Agenda Item	5.5
Report No	PLN/030/17

16/05498/FUL: Diageo Scotland Ltd
Talisker Distillery Carbost Isle Of Skye IV47 8SR

Report by Area Planning Manager

Description :Construction of car park and associated works.

PROPOSED CAR PARK
EXTENSION GA

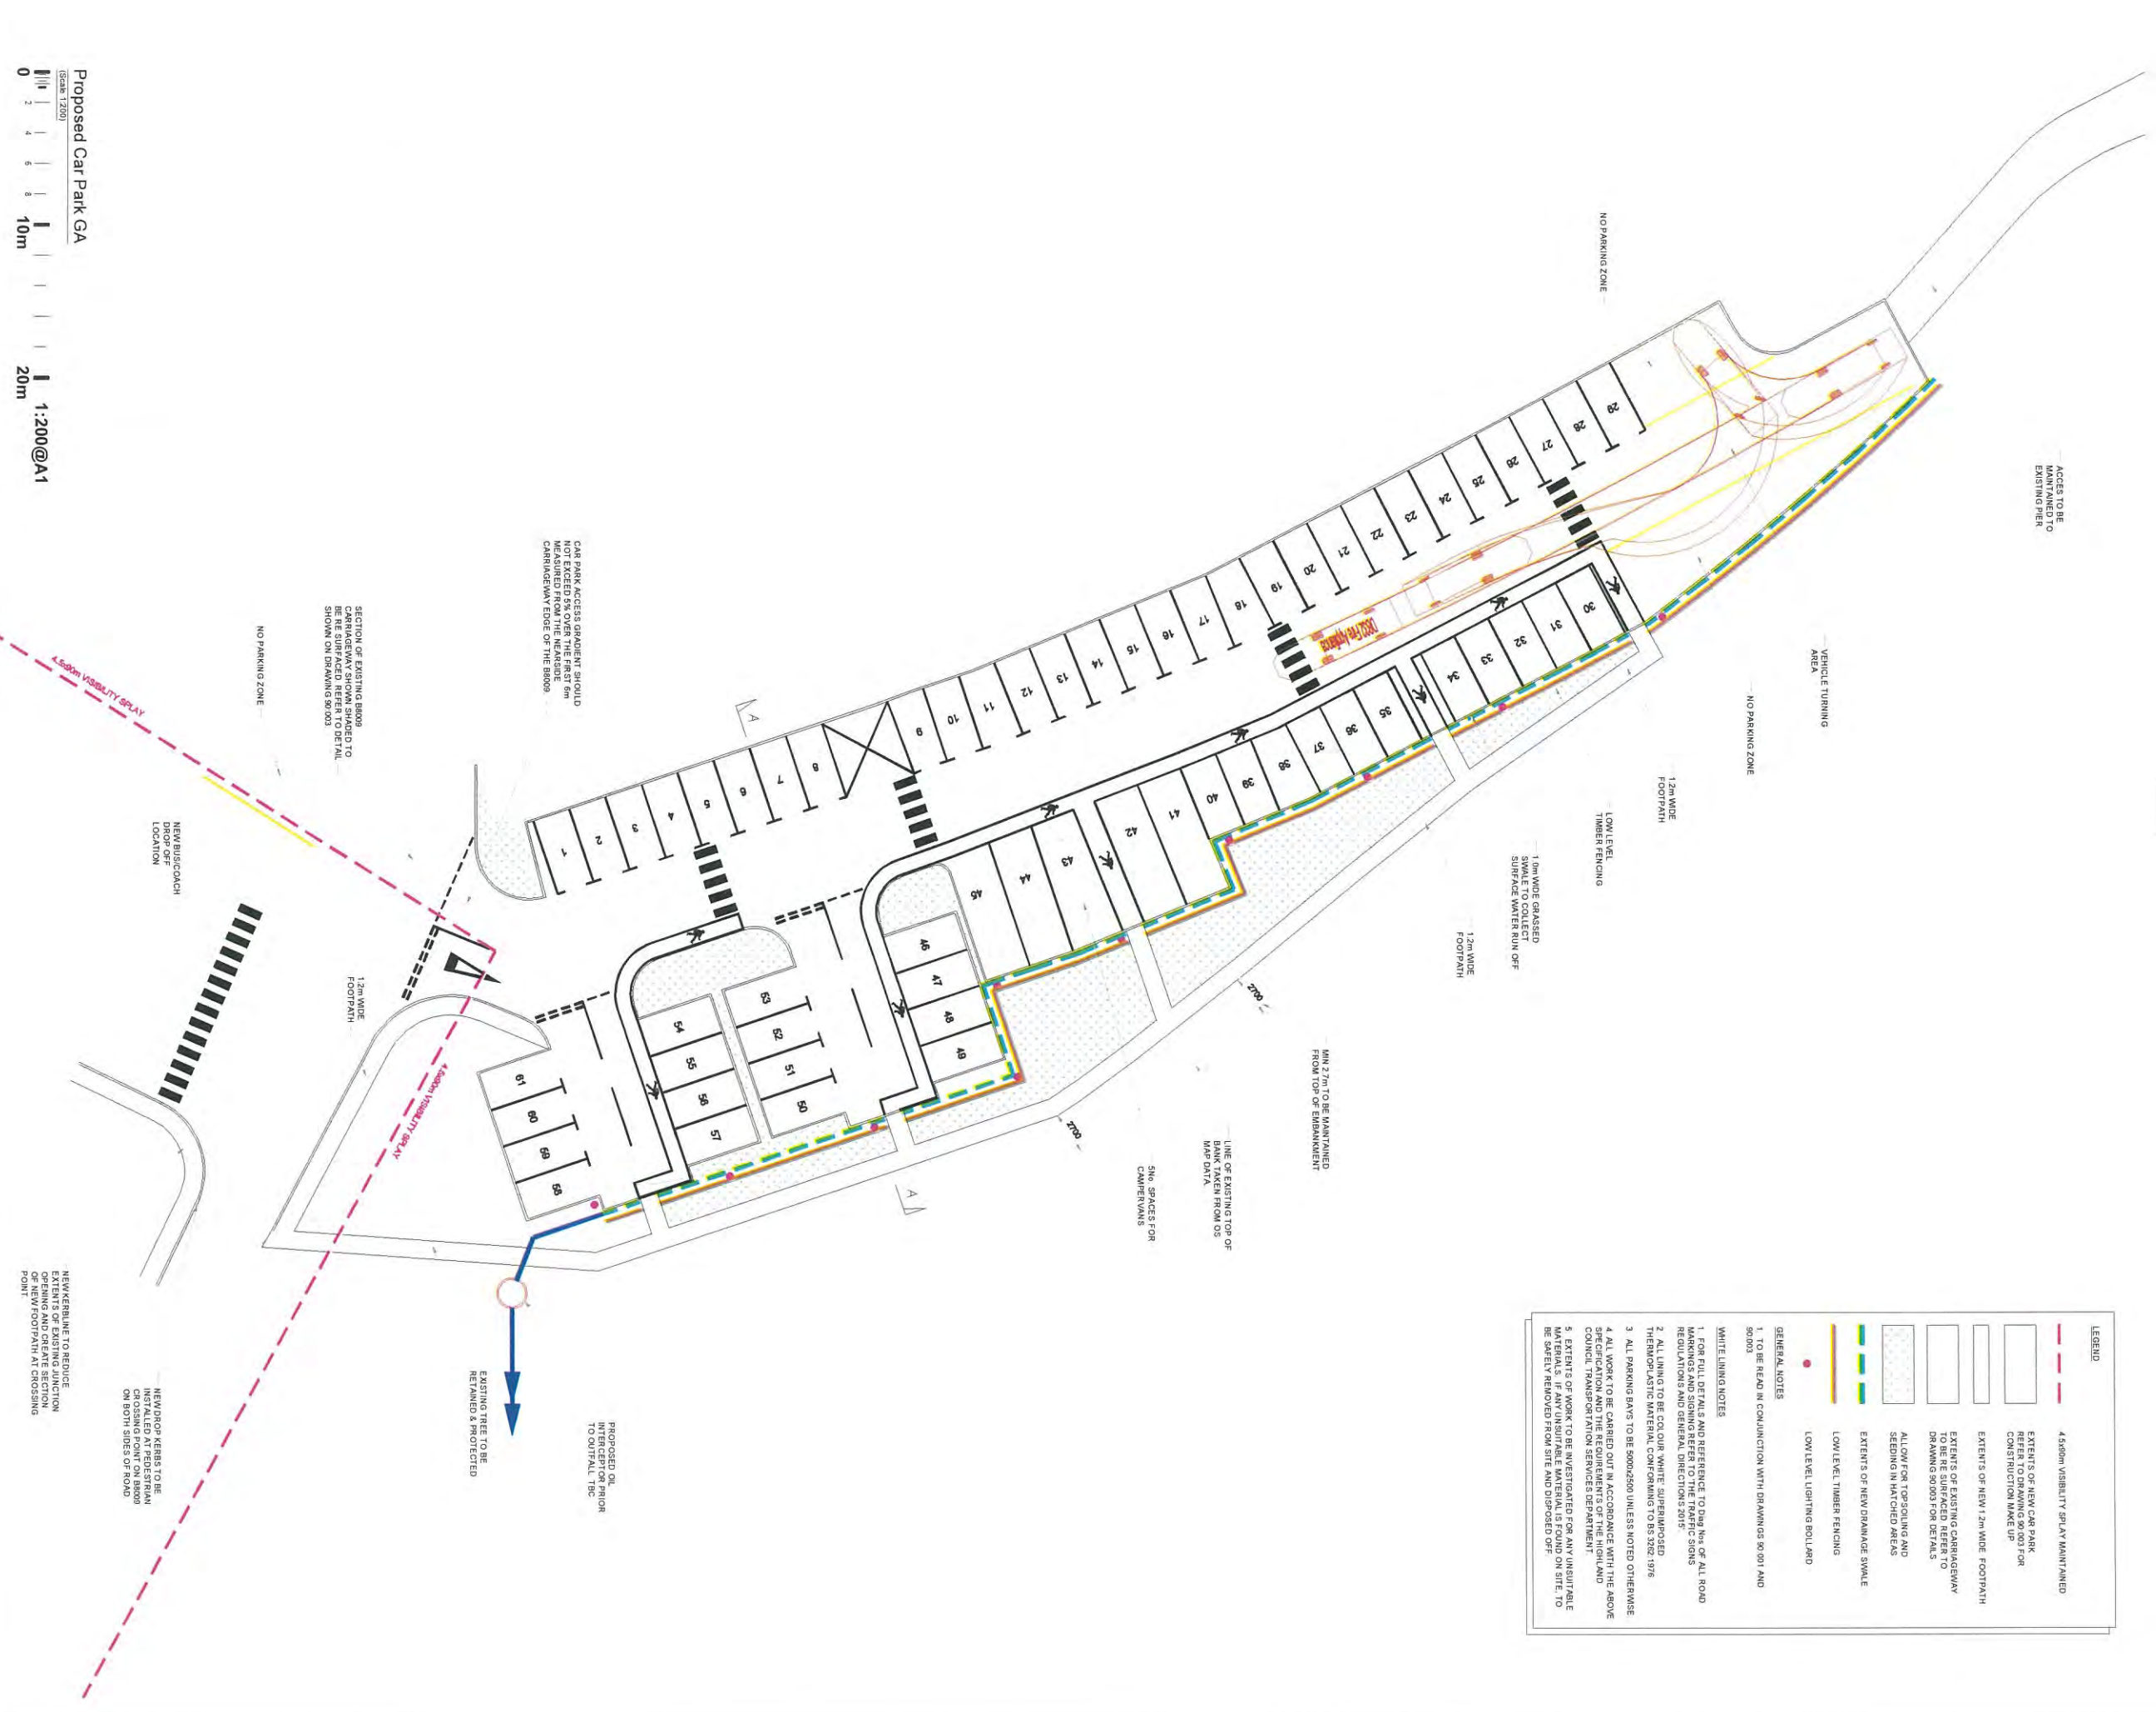
8.25 The plans submitted with the application at the time of registration indicated that a 1 m wide 0.6m high bund was proposed along the eastern, loch side edge of the car park. SEPA indicated that this bund could affect or exacerbate localised flooding problems and recommended that it be removed. Revised plans submitted in March 2017 removed the bund as requested. It is considered that based on the revised plans the development of the site in the manner proposed will safeguard flood storage and conveying capacity and therefore not increase the risk of flooding to other more areas of the village.

Drawing No. AZ70566:90:002		Revision C
Revisions	Date	Drn.
A DRAWING REVISED FOLLOWING COMMENTS FROM HIGHLAND COUNCIL	16.01.17	KP
B DRAWING REVISED FOLLOWING COMMENTS FROM HIGHLAND COUNCIL	21.02.17	KP
C ZEBRA CROSSING ON PUBLIC ROAD REMOVED FOLLOWING COMMENTS FROM HIGHLAND COUNCIL	16.03.17	KP

**PROPOSED ROAD MARKINGS
AND SIGNAGE GA**

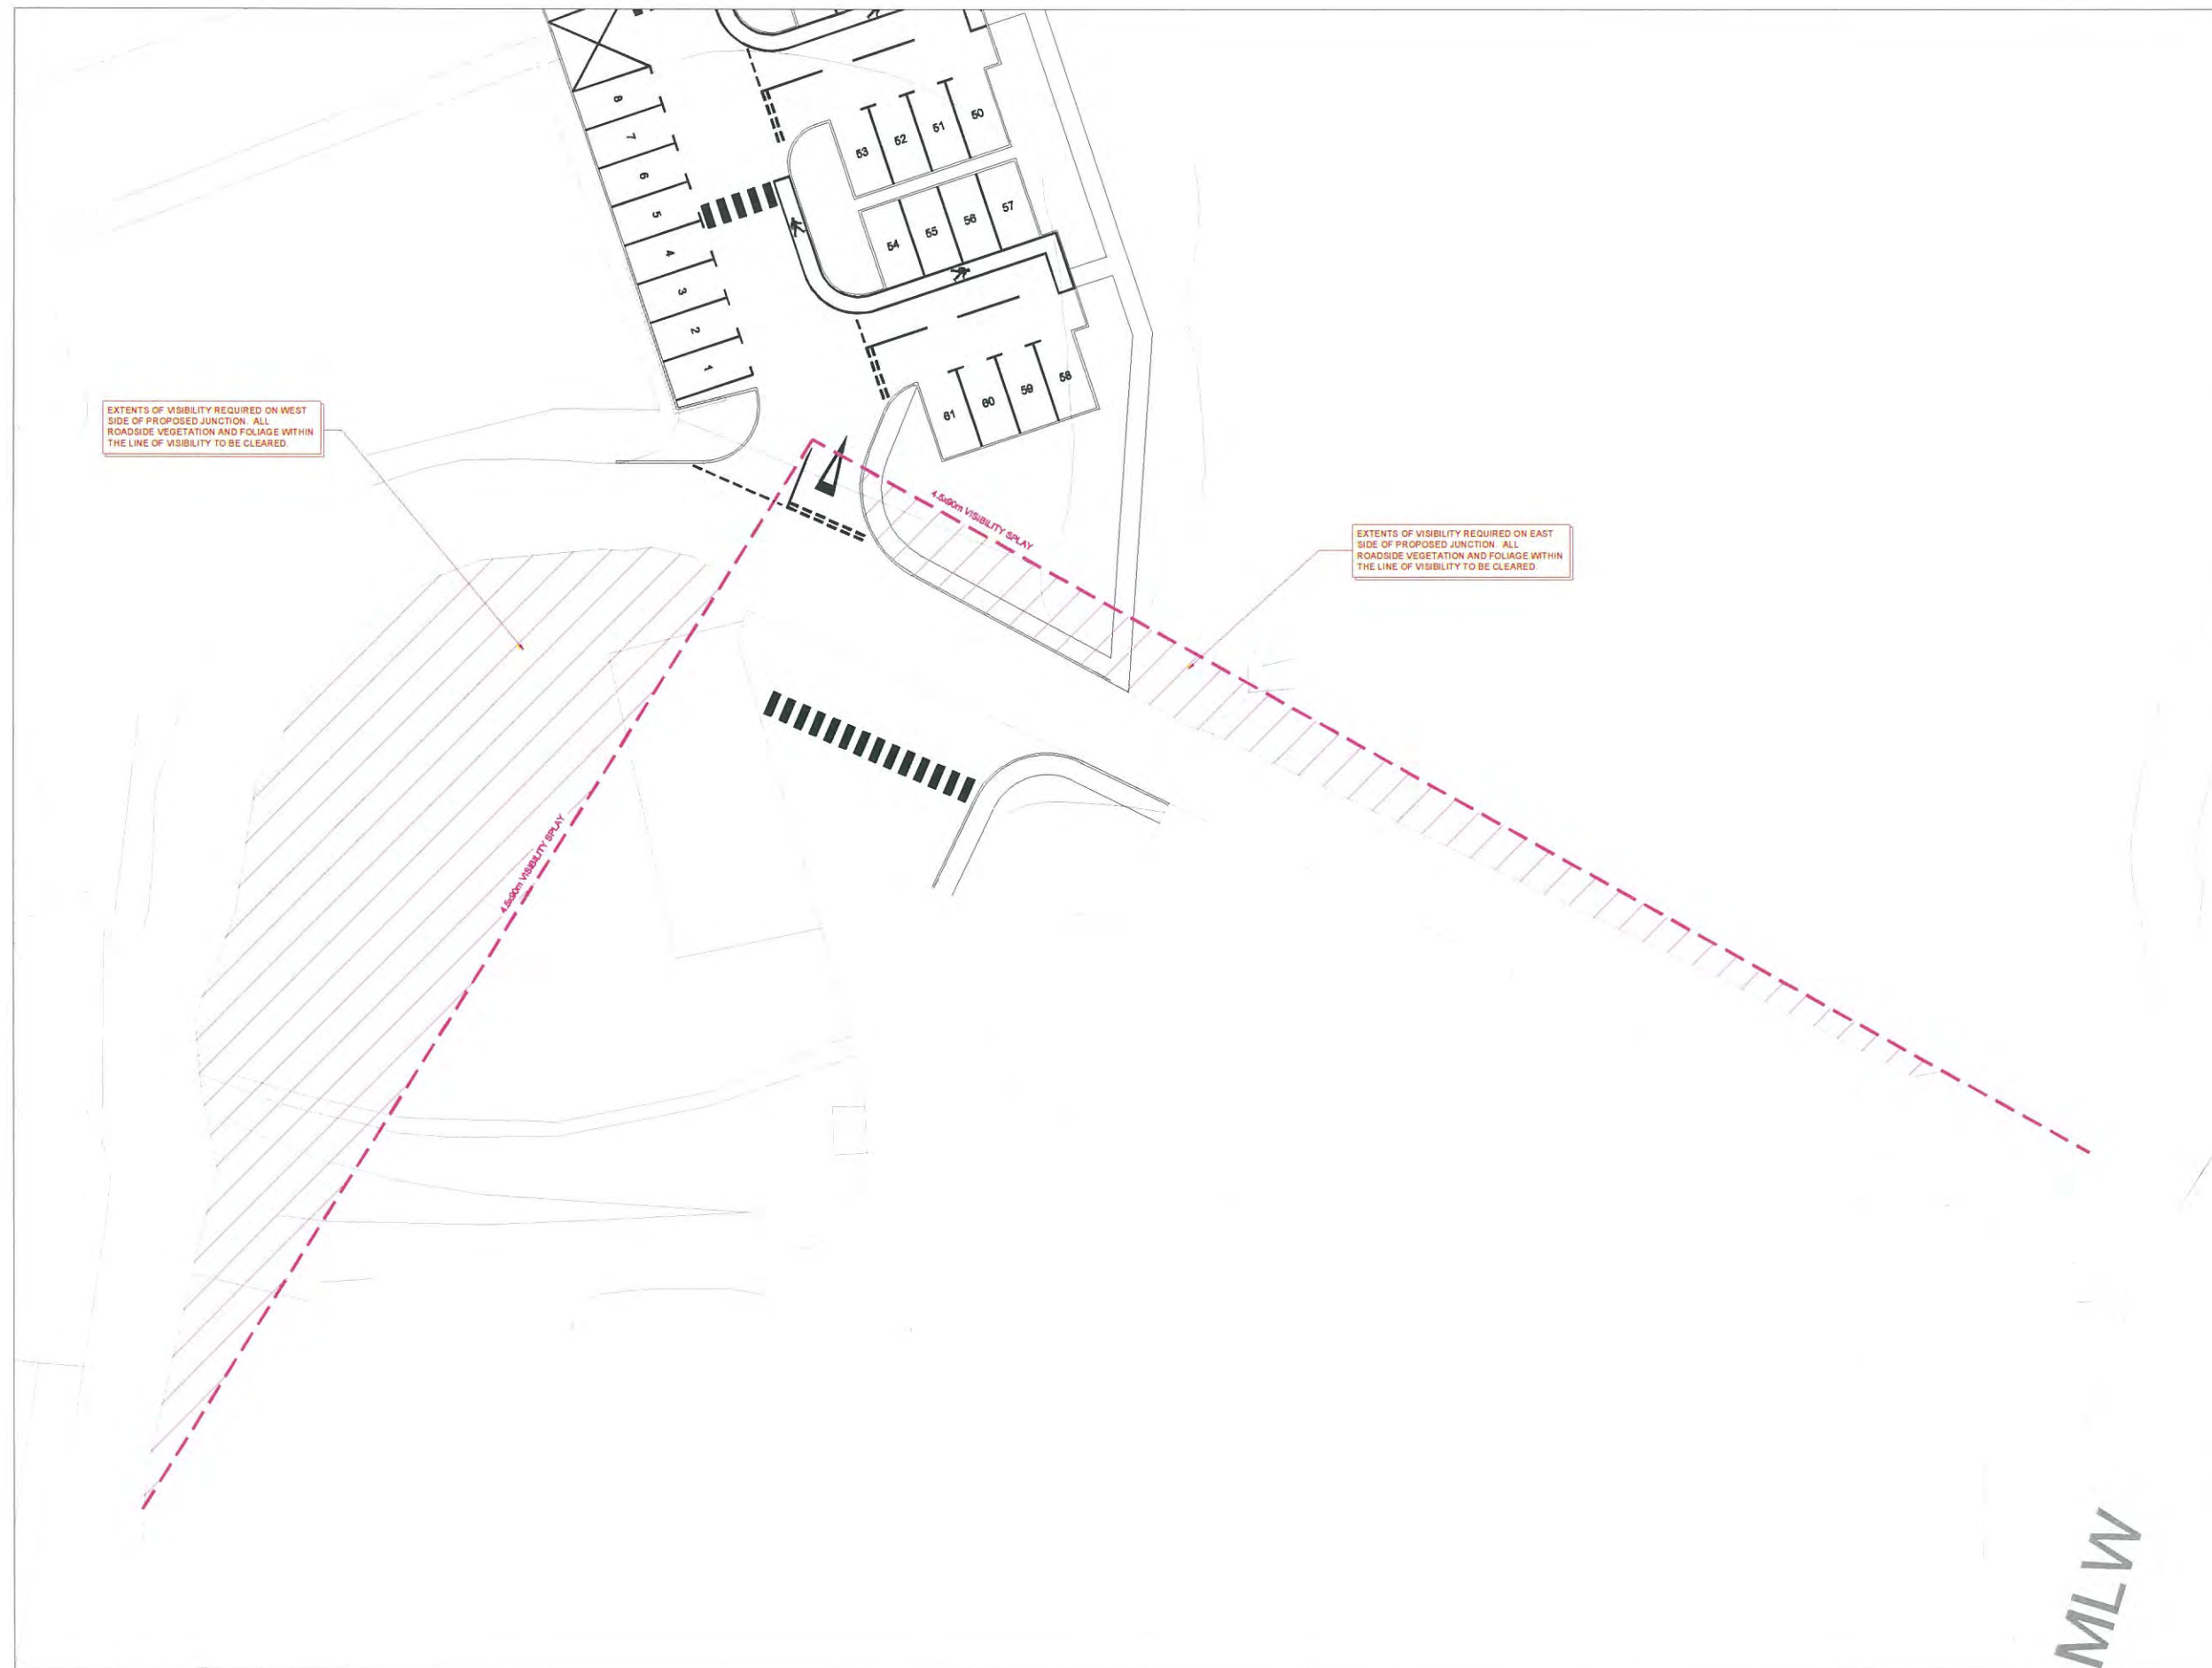
4. Prior to first use of the car park hereby approved the alterations to the junction with the B8009 as well as the installation of the traffic and pedestrian signage on drawing AZ70566-90-004 A shall be completed to the satisfaction of the Planning Authority. Details of the pedestrian signage shall be as agreed with the Planning Authority.

5. Prior to first occupation of the car park the “green walkway” and white lining shall be completed in accordance with the details on drawing AZ70566-90-004 A to the satisfaction of the Planning Authority.
